APPLICATION FOR CONSTRUCTION OF PAVED SIDEWALK/ DRIVEWAY

Application No. 11527 Date: 4-25-19

Adress: 93 Atlantic St New Bedford MA
Street City State zip code

Driveway Review

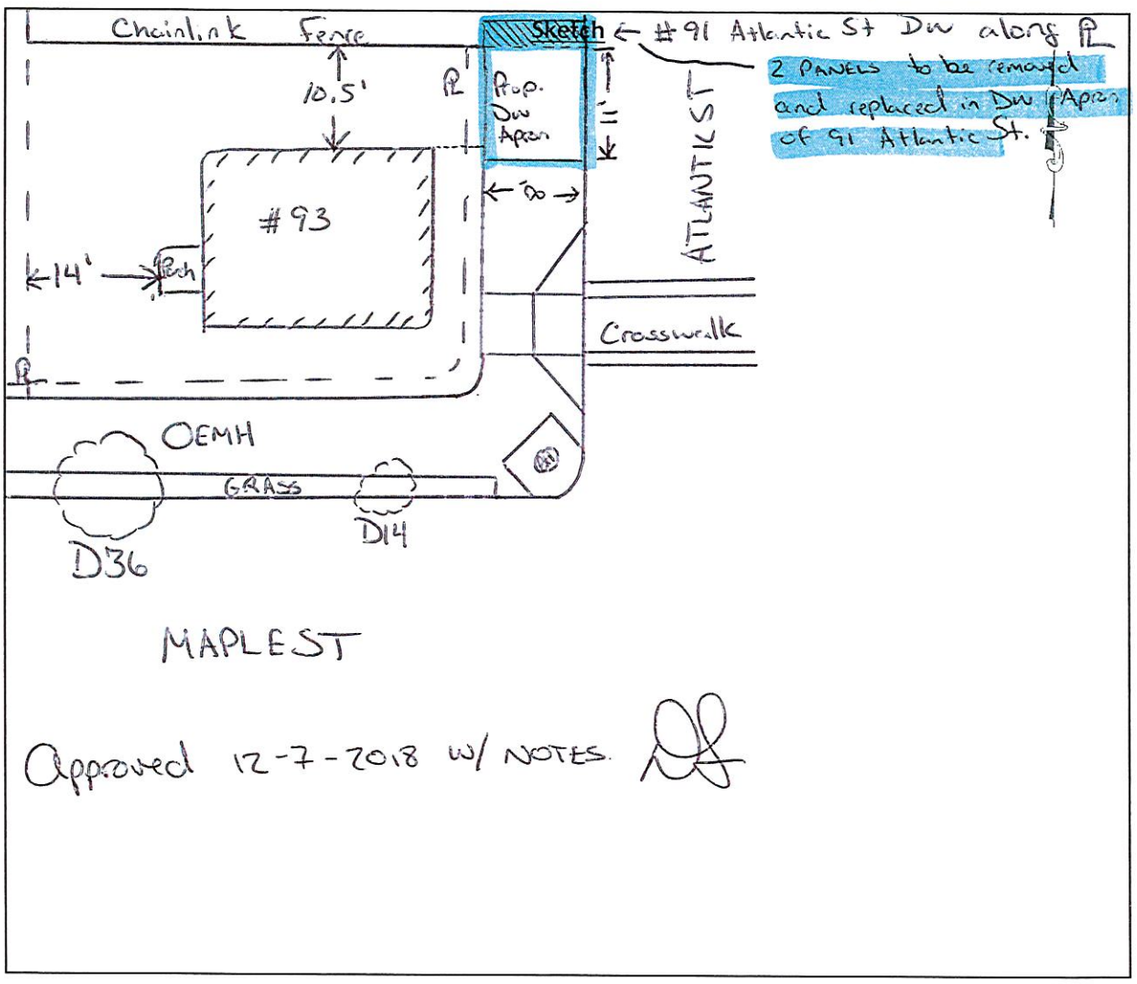
- No space for DW??

12/7/2018 - Remove Existing 11' x 3' Conc. Sidewalk

- Install New 11' x 8' Conc. DW Apron

- Will require Removal & Replacement of 4' x 8' area of driveway apron at 91 Atlantic

Granite Curb: 11 ft Remove & Return

Approved 12-7-2018 w/ NOTES.
